5/21/2010

From: Don Decker
625 W Ward Ave
Ridgecrest, CA 93555

Subj: Comments on the draft SA/DEIS Document, Docket Number 09-AFC-9, "Solar Millennium, Ridgecrest Solar Power Project"

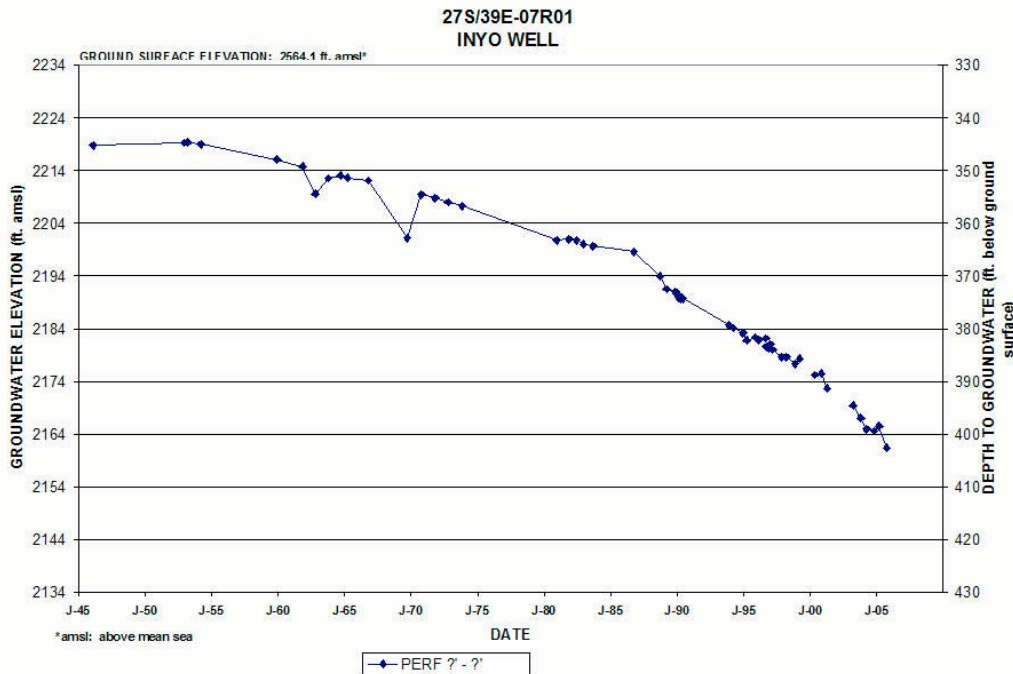
There are many more examples where the omission of a task timeline makes the mitigations proposed completely uncertain or even invalid. By ignoring the timeline SM is apparently free to prorate construction water use over the life of the project. This was done by incrementally adding of the construction water to the annual operational water use. However, the construction water impacts occur in the earliest phases of the project, and these impacts demand not only a quantitative mitigation but a *timely* mitigation as well. This is not a casual criticism, as the construction water use will increase the annual quantity of groundwater pumped from the IWVWD SW well-field during construction by as much as 50%. The percentage increase depends upon the length of the construction period. The IWVWD has in recent years shifted a major portion of its pumping for existing customers into the very area that the water for SM will also be taken. Wells in the area were showing declines of about 1 foot per year through the 1980's and into the 90's. As the IWVWD pumping has increased in this area, water levels in monitoring wells in the area have experienced accelerating declines in water levels. These same wells are now showing water level drops of approximately 3 feet per year.

The pumping of SM construction water will place an additional *immediate* burden on the already overdrafted aquifer and would have a serious negative impact on the overlying

water right well owners in the greater vicinity. **Spreading out the construction water mitigation over the life of the project completely ignores this reality and is not a mitigation that meets CEQA requirements for a *timely* and accurate mitigation of impact.**
